FORD 4R100 "UPDATE HANDBOOK"

FORD 4R100 "UPDATE HANDBOOK"

Since the introduction of the 4R100 transmission in model year 1998, there have been many engineering changes to improve Pleaseability, Reliability and Durability concerns. These changes have affected most every part used in this transmission. This "Update Handbook" will explain each change, the reason for the change, and any parts interchangeability concerns created by the change, along with any part numbers needed to update your transmission.

Figure 43

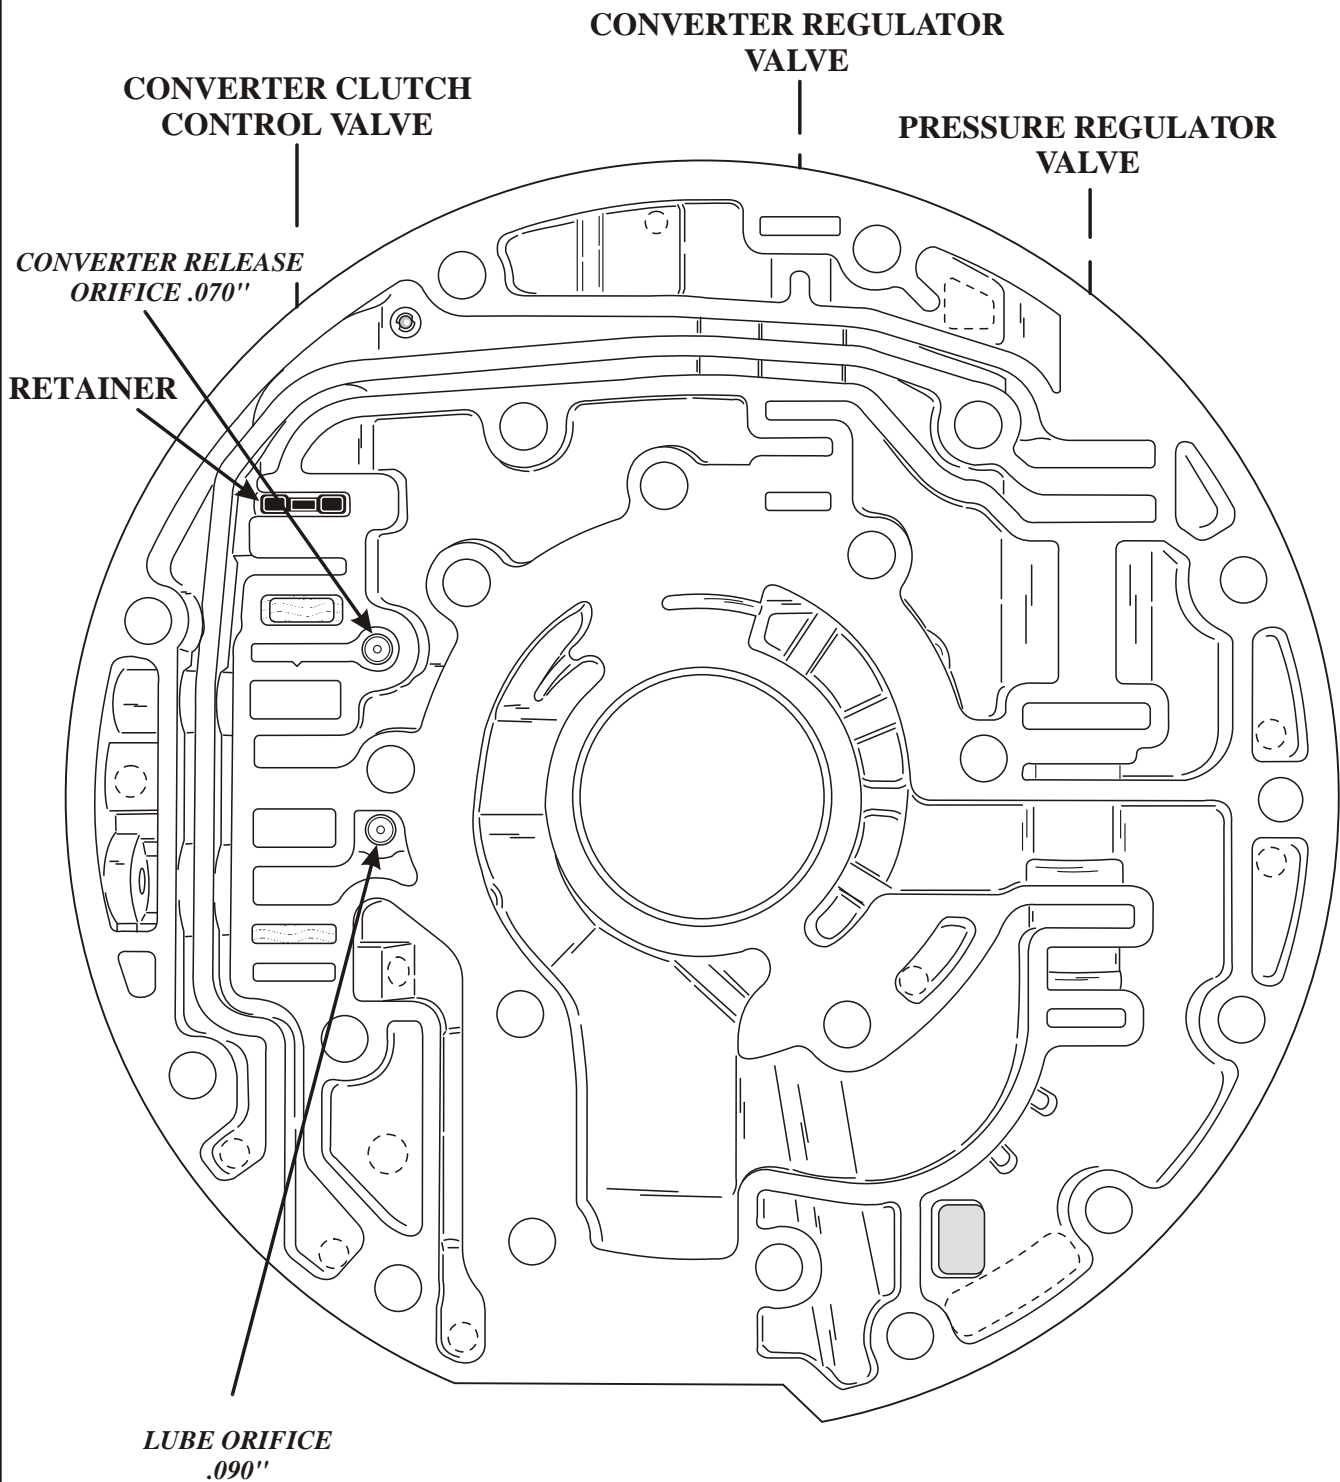
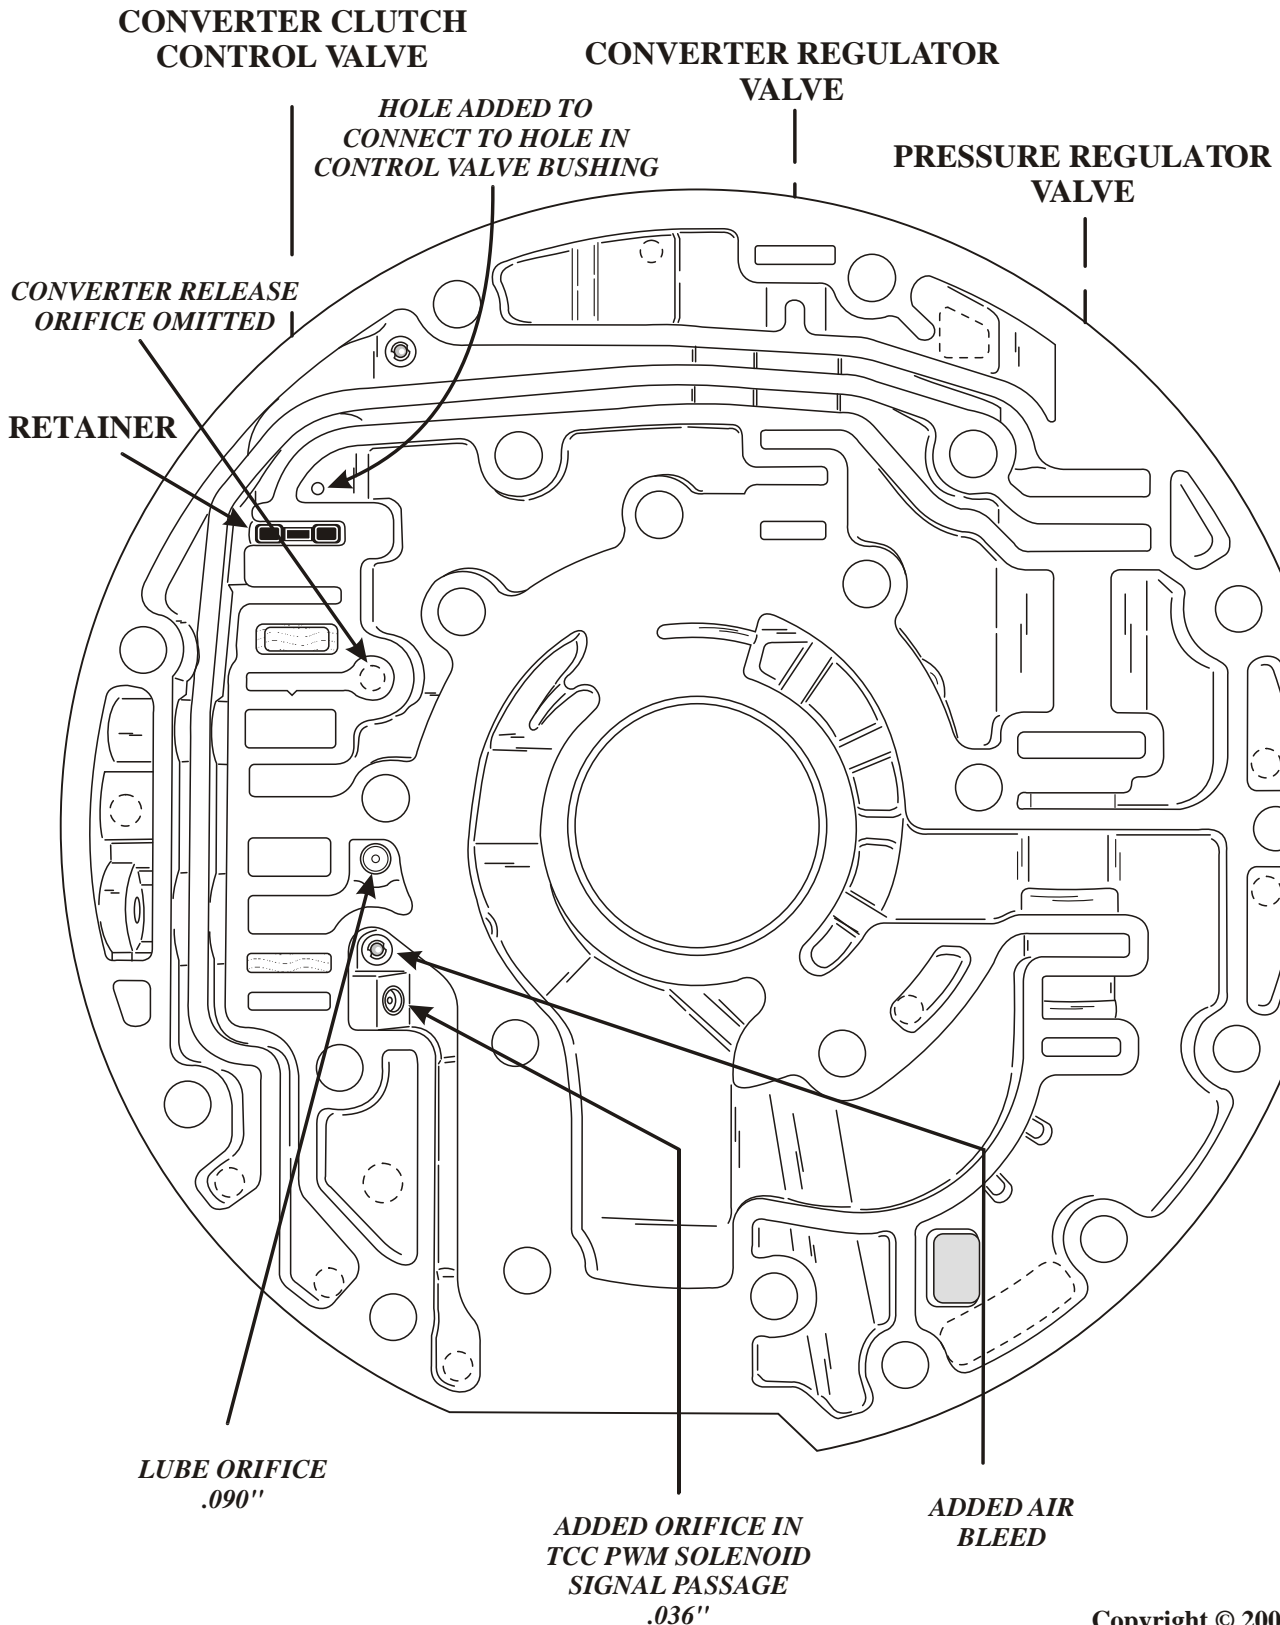
- A .036" orifice and an air bleed were added to the TCC Solenoid signal passage, as shown in Figure 43.
- The Converter Clutch Control Valve's rear spool was enlarged approximately .070". There was also a bushing and valve added to the end of the valve train, as shown in Figure 41.

- A hole was added to the pump cover to connect the Converter Clutch Control Valve Bushing to Converter Regulator Valve oil, as shown in Figure 43.
- The Converter release orifice in the NON-PWM pump cover, as shown in Figure 42, was removed from the PWM pump cover, as shown in Figure 43.

Figure 45

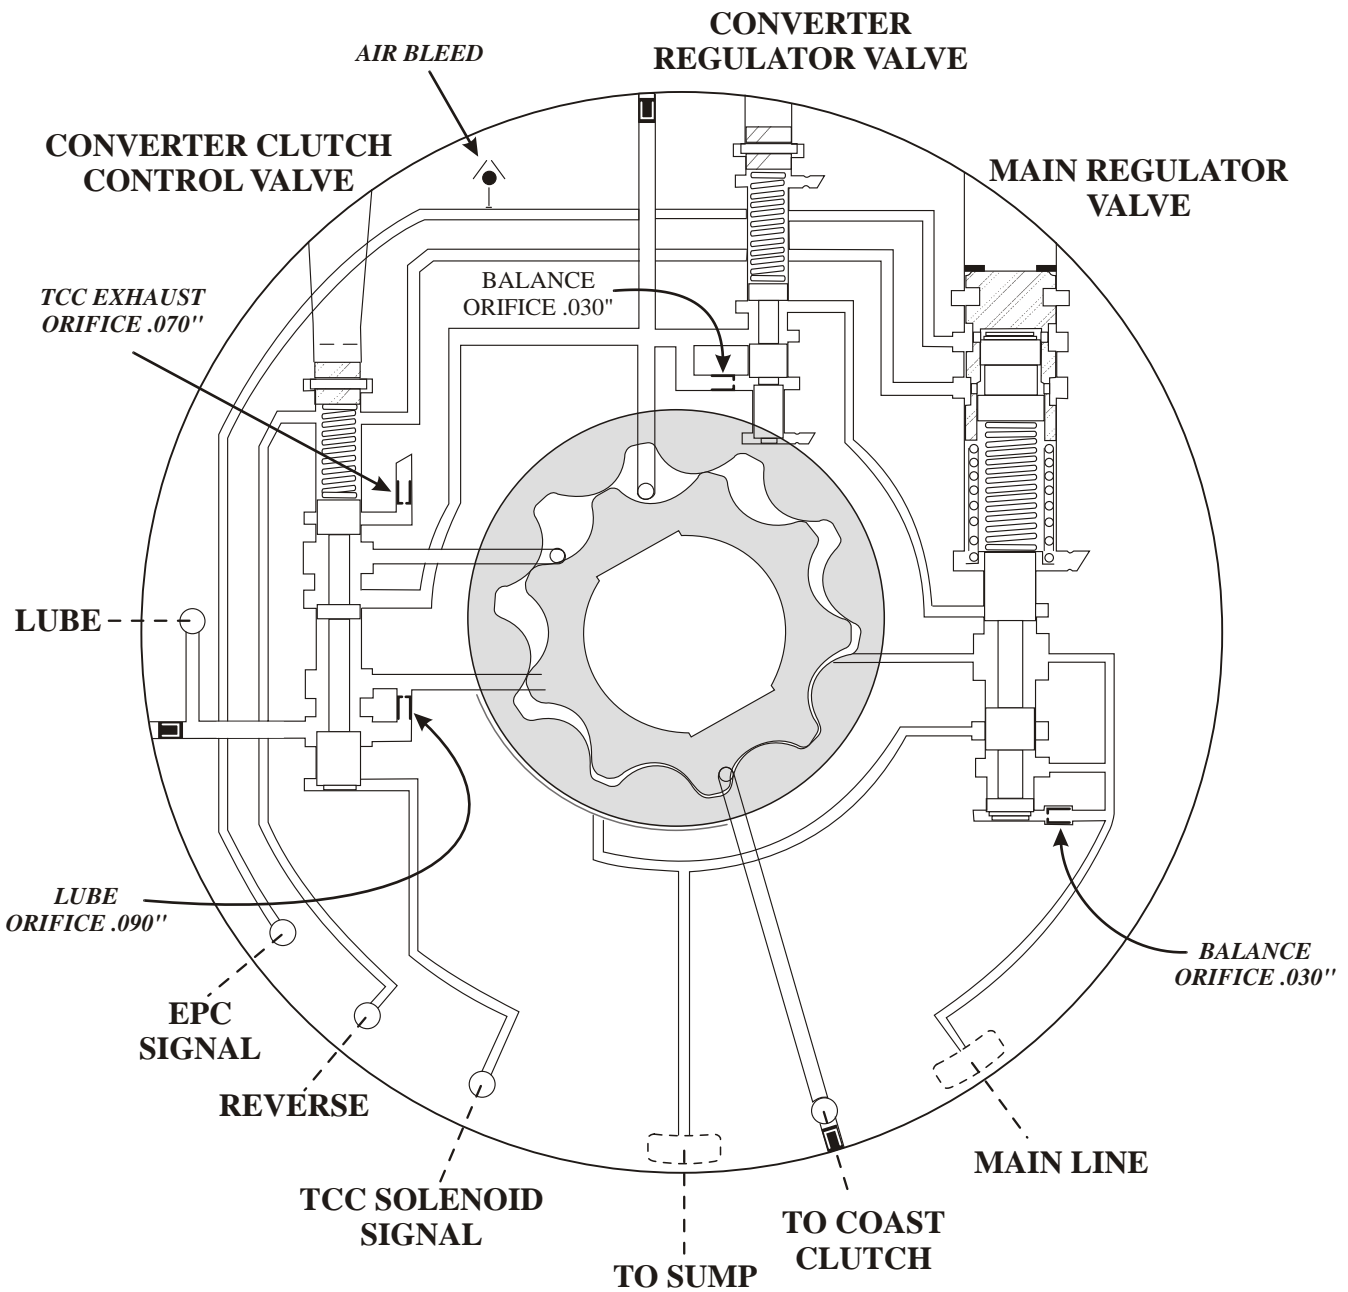
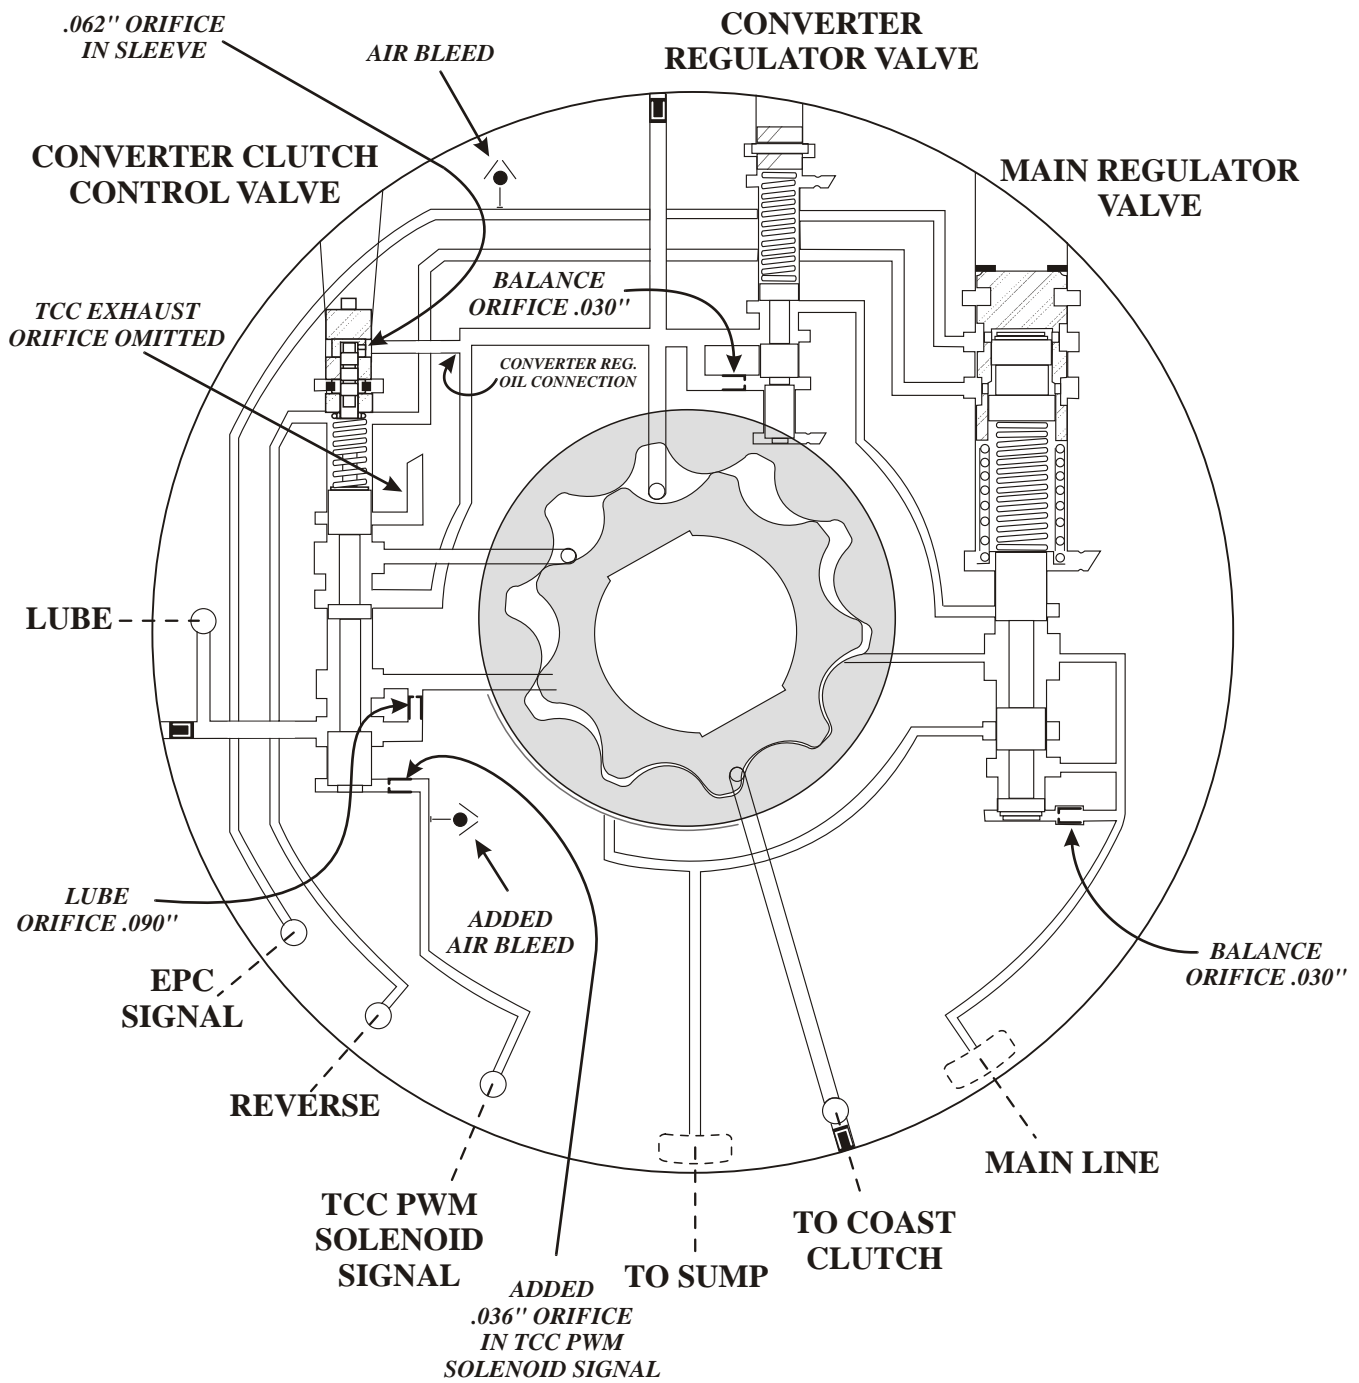
- Refer to Figure 44 for the NON-PWM pump hydraulic circuit.
- Refer to Figure 45 for the PWM pump hydraulic circuit with all hydraulic changes shown.

Figure 47

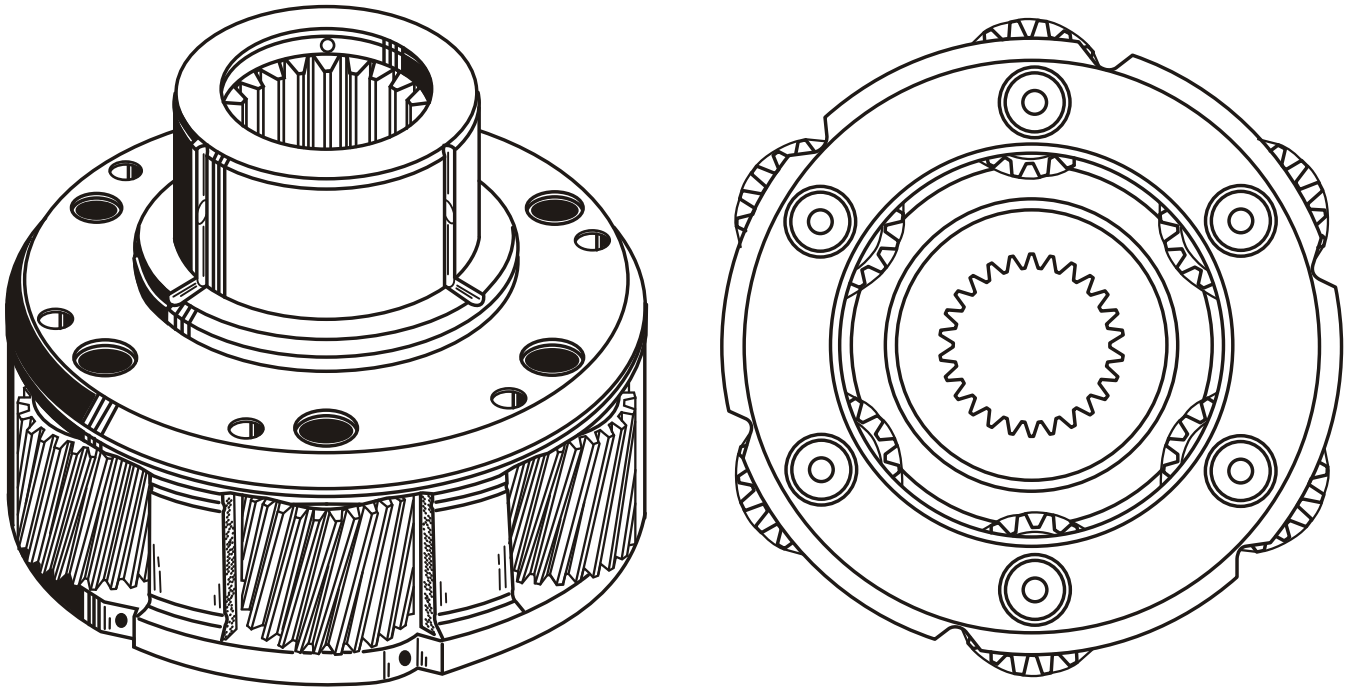
CHANGE: Beginning at the start of production for all 1998 model E4OD transmissions, *some models* will be equipped with a new design 6 pinion forward planetary carrier (See Figure 47), and a new design 6 pinion reverse planetary carrier (See Figure 48).

- (1) FORWARD PLANETARY CARRIER - Now has 6 pinions instead of the previous 4 pinions for increased torque carrying capacity and increased durability (See Figure 47).
- (2) REVERSE PLANETARY CARRIER - Now has 6 pinions instead of the previous 4 pinions for increased torque carrying capacity and increased durability (See Figure 48).

The new design forward planetary carrier *will back service all models* of the E4OD, but it *does require* the latest design forward ring gear hub and bearing assembly, as there are no holes for the previous design thrust washer (See Figure 47).

Forward Planetary Carrier (6 Pinion)	F81Z-7A398-CA
Reverse Planetary Carrier (6 Pinion)	F81Z-7D006-AA

Figure 49

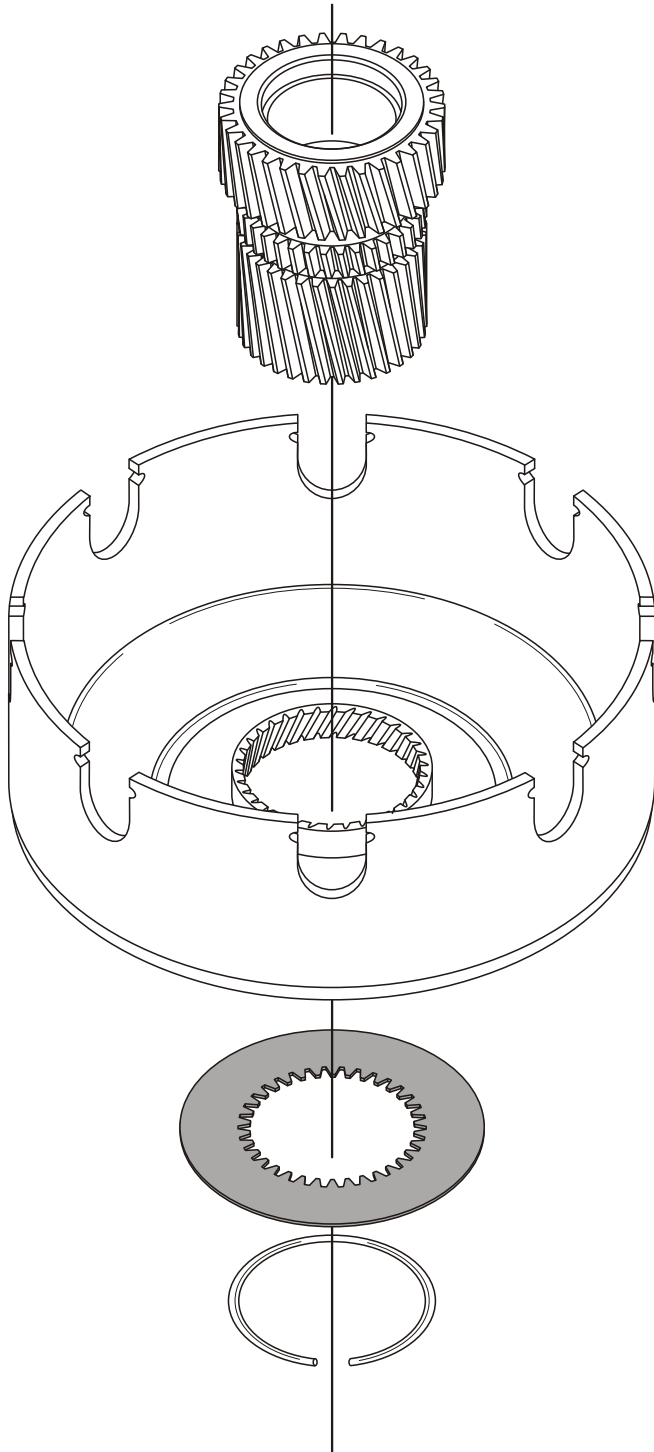
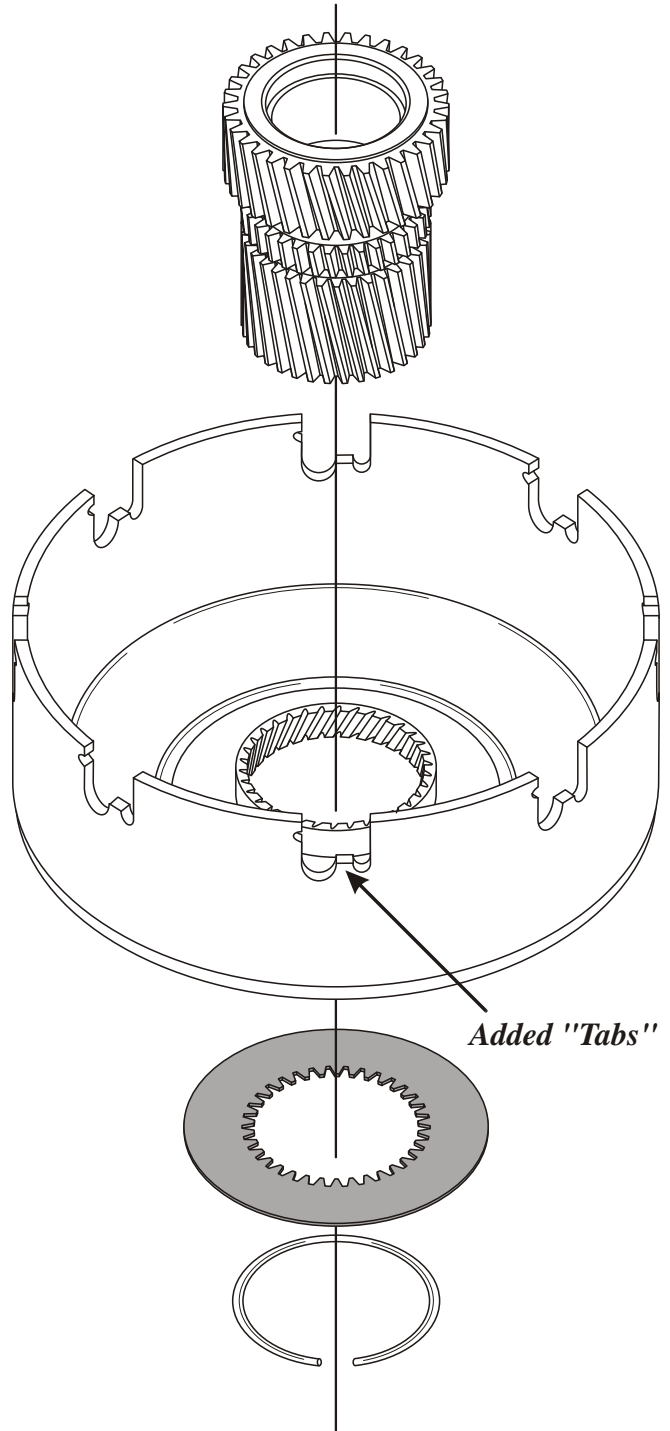
CHANGE: There is now a new design Sun Shell with "Tabs" added to the center of the sun shell slots, as shown in Figure 49, implemented by Ford Motor Co. as a running change, during the 2000 model year. This change eliminated the need for the number 8 thrust washer between the forward and direct drums.

- (1) INPUT SUN SHELL - New design have "Tabs" added to the center of the sun shell slots, as shown in Figure 49, which now support the direct drum for the required clearance between the direct and forward clutch housings, and allows elimination of the number 8 thrust washer, as shown in Figure 50.
- (2) DIRECT CLUTCH HOUSING - Manufactured "Without" slots in the center hub, as they were no longer needed to accept the number 8 thrust washer tabs. Both design direct drums are illustrated in Figure 50, and cut-away in Figure 51.
- (3) NUMBER 8 THRUST WASHER - Eliminated (See Figure 50 and 51).

PREVIOUS DESIGN SUN SHELL "No Longer Available From Ford"

NEW DESIGN SUN SHELL Hardened = YC3Z-7D064-BA Regular = YC3Z-7D064-AA

*May Be Used With "ONLY"
The Previous Design Direct Drum
And Requires The No. 8 Washer
(See Figure 50)*

*May Be Used With
Both Design Direct Drums
With Or Without Washer
(See Figure 50)*
